## Change Order #7 Las Milpas Road

Project: Las Milpas Road  
Contract: C-22-0094-09-06(ARPA 22- 122-109)  
Limits: McColl Rd (FM 3062) to 10<sup>th</sup> Street (FM 336)

### Description: **Change Order No. 7 Summary**

**CONSTRUCTION CONTRACT CHANGE ORDER NUMBER: 7**

**LAS MILPAS ROAD PLAN AND PROFILE STA. 143+00 TO STA. 148+00**

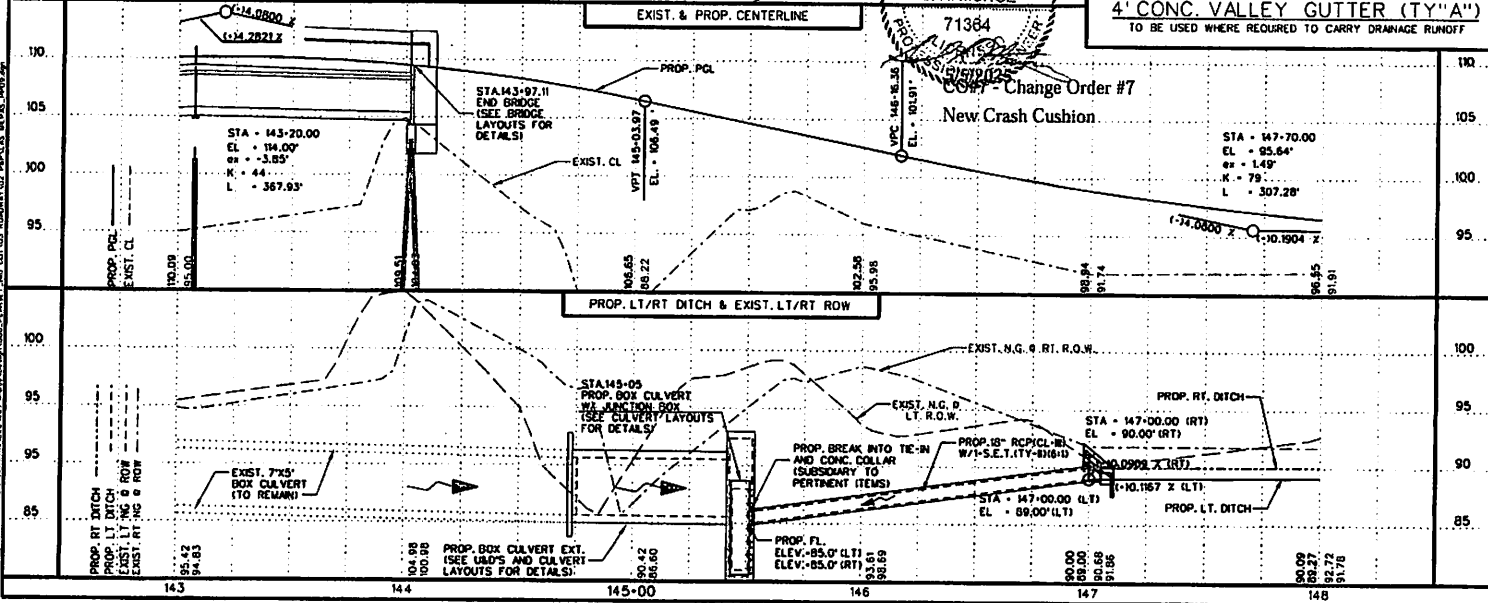
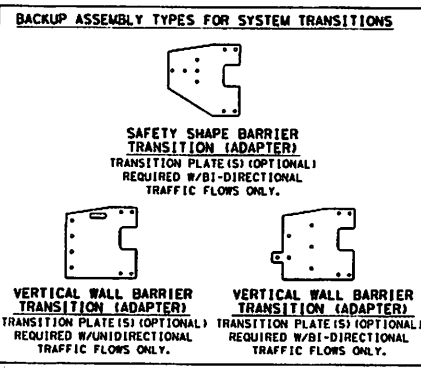
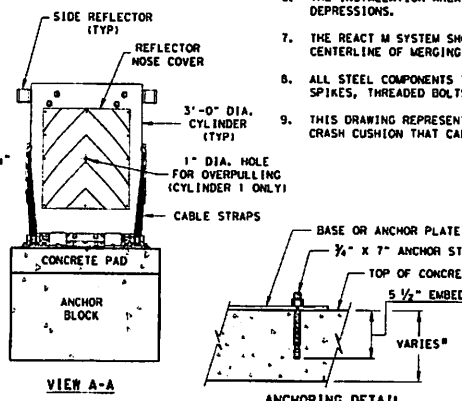
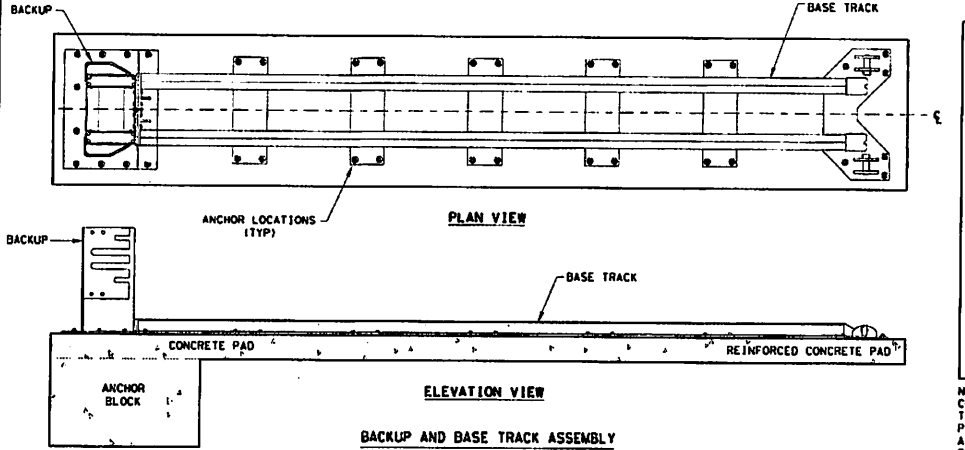
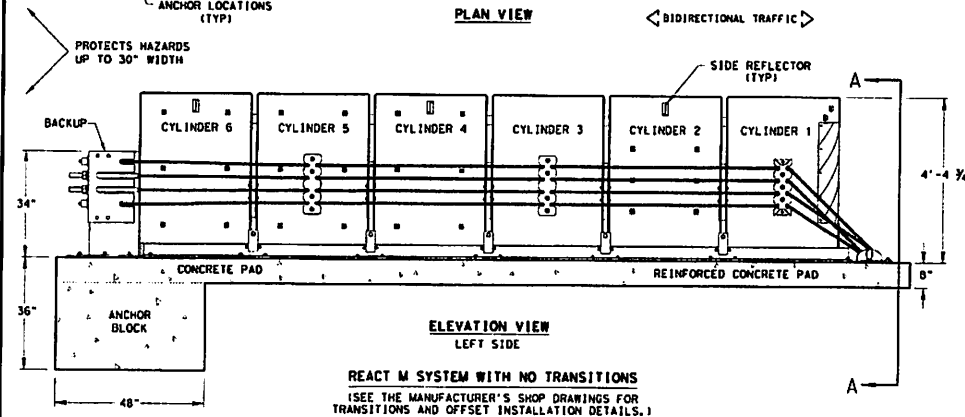
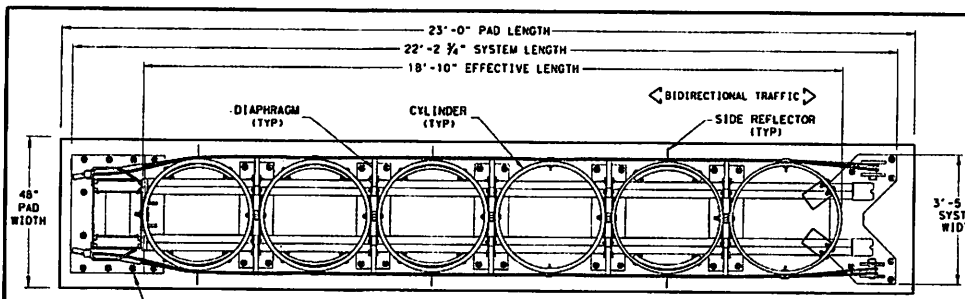
Change Order No. 7 provides additional funds to install four (4) crash cushion attenuators—two at each end of the newly constructed bridge over the San Juan Main Canal. These safety devices, essential for protecting motorists, were shown in the plans but were not originally included in GO Underground's scope of work. Their installation is required before the roadway can be opened to traffic.

Change Order #7  
New Crash Cushion

SHEET SUMMARY		
ITEM	DESCRIPTION	UNIT/QUANTITY
420	CL C CONC. (RAIL FOUNDATION)	CY 24
484	RP PFC (CL-RIBB)	LF 568
487	SLT CITY BRG	EA 2
529	CONC CRB 1 GUTTER VALLEY GUTTER	LF 201
545	CRASH CUSHION ATTEN.	EA 2
